UNITED STATES PATENT AND TRADEMARK OFFICE

10/730,471

Office Action Summary	Application No. 10/730,471	Applicant(s) KAISER ET AL.	
	Examiner JOSHUA D. ZIMMERMAN	Art Unit 2854

DETAILED ACTION

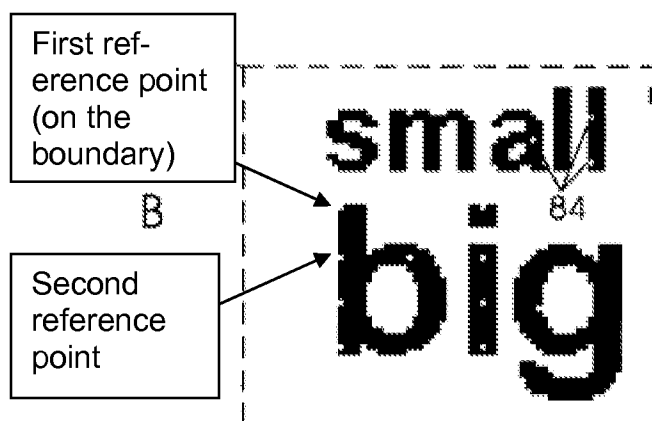
Regarding claim 4, AAPA further teaches “wherein the at least one reference point includes a plurality of reference points distributed in the image data a uniform grid over a representation of printing area of the printing form (see figure 5B).”

Regarding claim 5, AAPA further teaches “wherein the distance from a first reference point to a second reference point of the at least one reference point matches an extent of the boundary area (see the marked area of figure 5 below).”
